Certified Action of the City of Raleigh Planning Commission

Case File / Name: SP-46-13 / 2600 Glenwood

Nature of Case: A multifamily building comprised of 188 dwelling units on a 4.71 acre site that is zoned Office and Institution-2. Any development exceeding 15 dwelling units per acre in this zoning district requires Planning Commission review. The proposed density is 39.91 dwelling units per acre. The maximum density in this zoning district is 40 dwelling units per acre. This plan was submitted prior to September 1, 2013.

SP-46-13 – 2600 Glenwood – Preliminary Site Plan

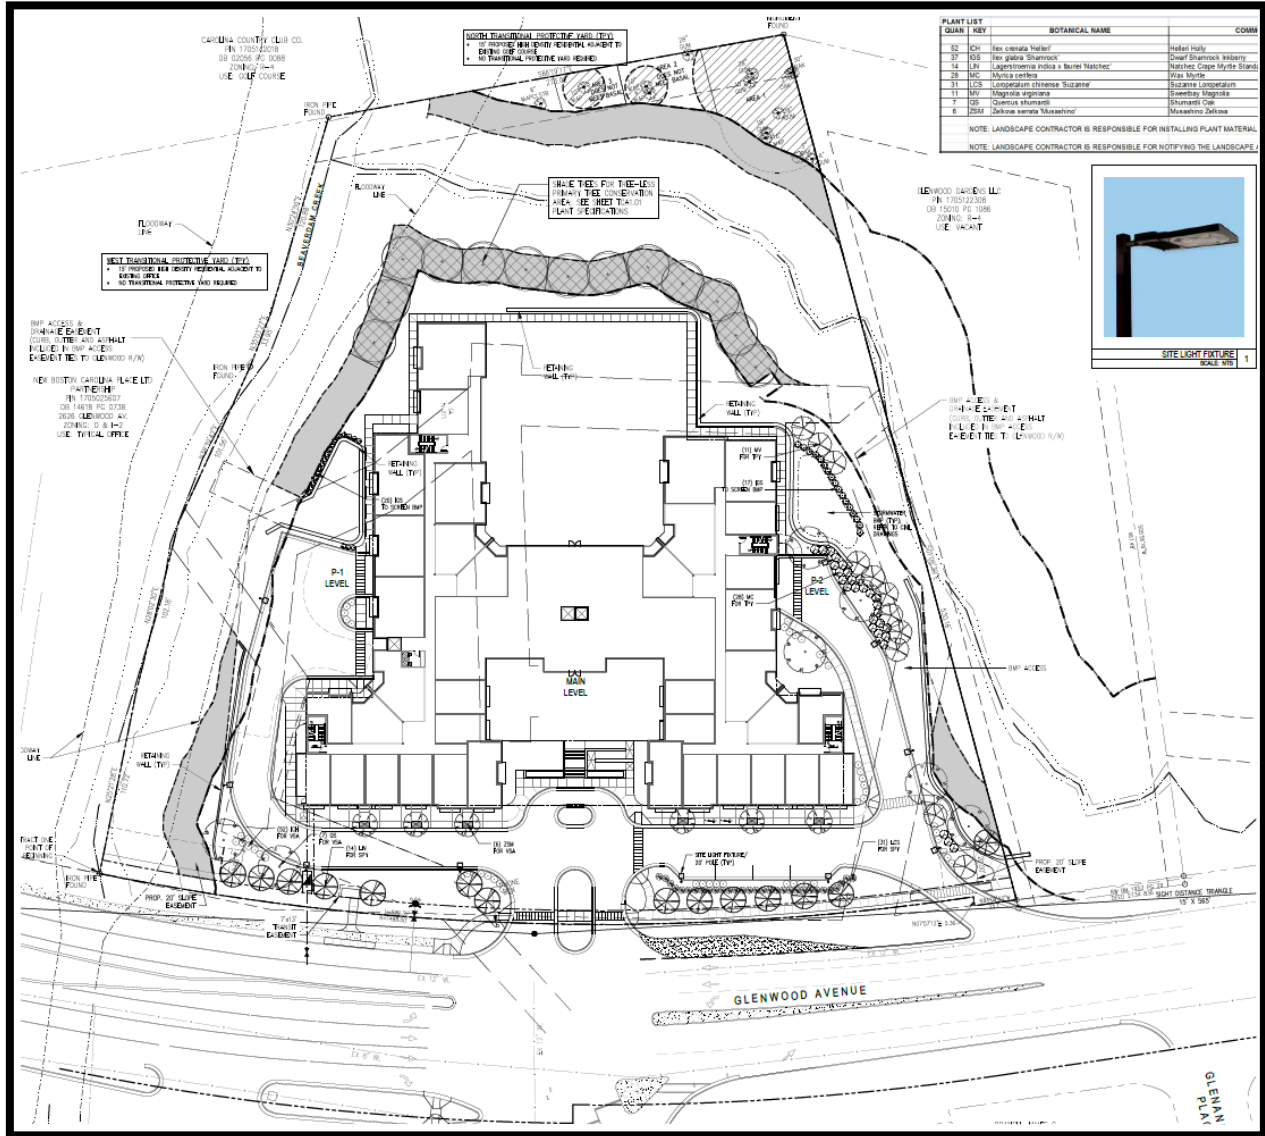
All primary building entrances should front onto a publicly accessible, and easily discernible, and ADA-compliant walkway that leads directly from the street to the front door to improve pedestrian access. **Include a pedestrian walkway from the building to the sidewalk on Glenwood on the west side of the drop off area.**

Quality architecture should anchor and define the public realm. Elements of With respect to quality architecture include architectural accents and features conducive to pedestrian scale and usage, such as a distinct base, middle, and top (for high-rise buildings); vertical and horizontal articulation; rooflines that highlight entrances; primary entrances on the front façade; transparent storefront windows and activated uses on the ground floor; and corner buildings with defining landmark features. **It is difficult to discern on the south elevation if the primary entrance provides a strong presence. Consider ways to emphasize this main entrance. Also, please indicate what material is to be used below the main level and masonry veneer. It looks different from the masonry veneer.**

The visibility of trash storage, loading, and truck parking areas from the street, sidewalk, building entrances and corridors should be minimized. These services should not be located adjacent to residential units and useable open space. **Consider additional and/or more prominent screening for the exposed parking deck levels.**

Encourage efficient site design, shared parking between complementary uses, and reduced amounts of impervious surface in parking lot design. **Consider pervious treatment(s) for parking areas not in parking deck.**

| 2. The Commission prefers the colors of materials shown in presentation model. They more in keeping with surroundings (cream, brick). | The applicant will share material color selections for Appearance Commission comment in the review session to be scheduled prior to Building Permit Request. |
| 3. Suggest refining entry sequence into front courtyard. Perhaps reorient stairs to the side or add an intermediate terrace. | The entry sequence has been revised in accord with recommendation: Single set of stairs, integral planter for specimen trees (Tree-Form Nellie Stevens Holly). |
| 4. The Commission suggests the inclusion of public art, verticality, use of screening techniques in entry courtyard. | The recommendations for the entry sequence have been incorporated; the public art recommendation will be studied prior to Building Permit Request, but it is not a committed element at this time. |
| 5. Consider the vertical face of the building and how it meets ground plane, and tie back to the land in a more deliberate way. | The applicant prefers the current treatment, but will continue to evaluate this recommendation as the plans are refined for Building Permit Request. |
| 6. The Commission suggests plantings that suggest wetland in BMPs. | The BMPs are now designed as "Stormwater Wetlands", and the applicant will provide plantings that mimic or follow the character of a native wetlands. Dwarf Inkberry will be utilized at water's edge to provide screening and aquatic plantings will be installed in the interior of the BMP device. |
